Adapting the FC_Port definition to VN_Ports

Bob Nixon

4 Instructions to editor

4.2 Changes to FC-FS-3 version 0.50

Figure 2 — Entity authentication specification perspective

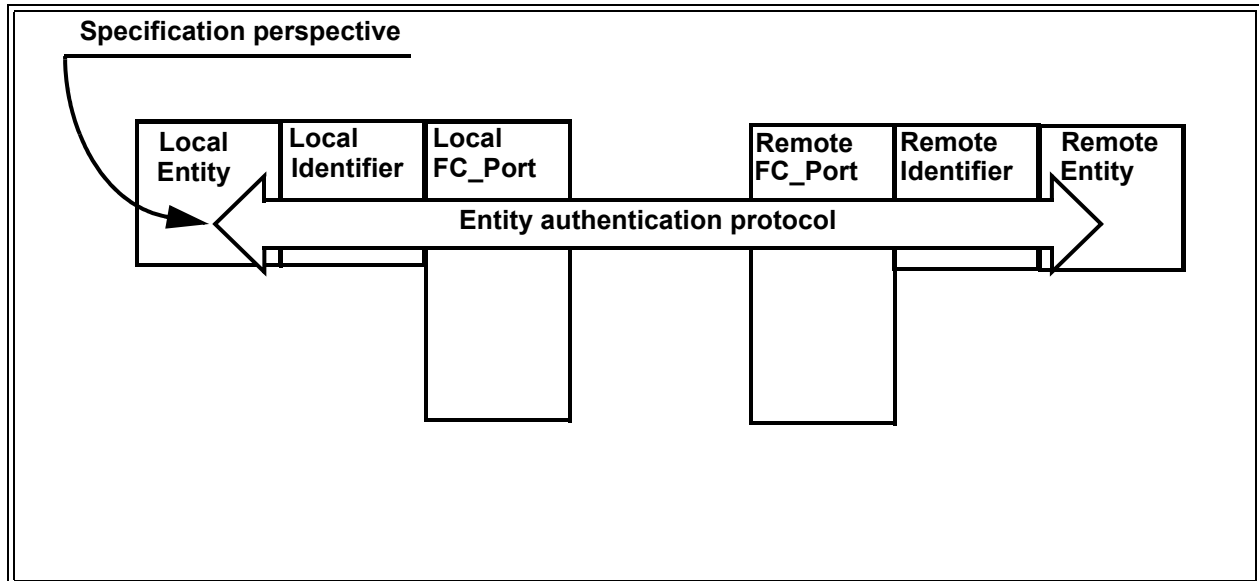
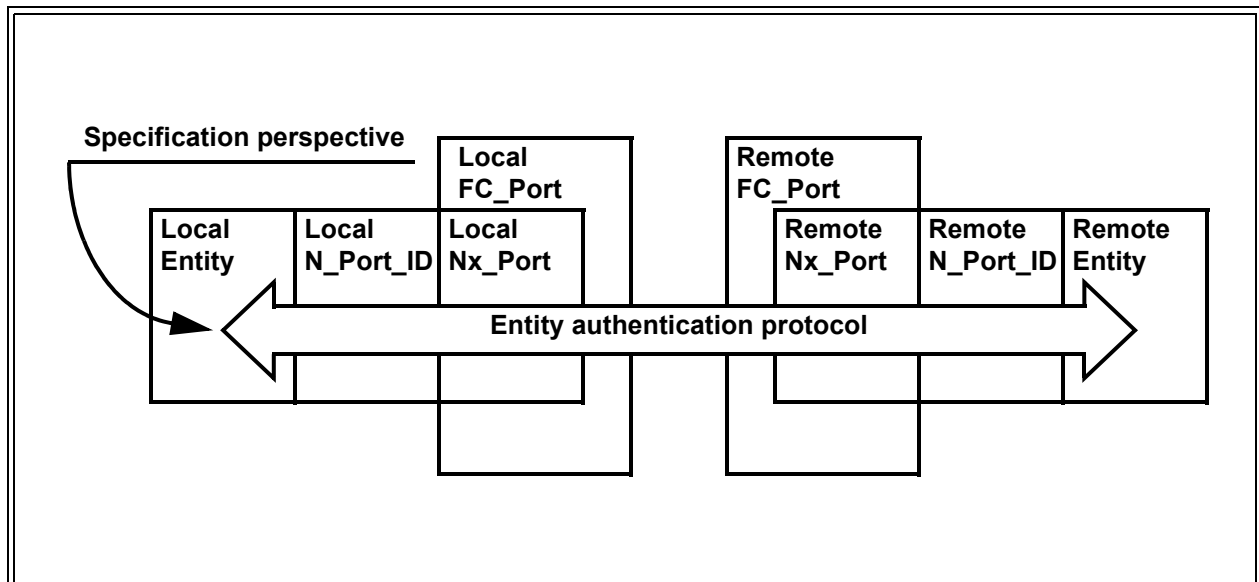
Replace figure 26

with
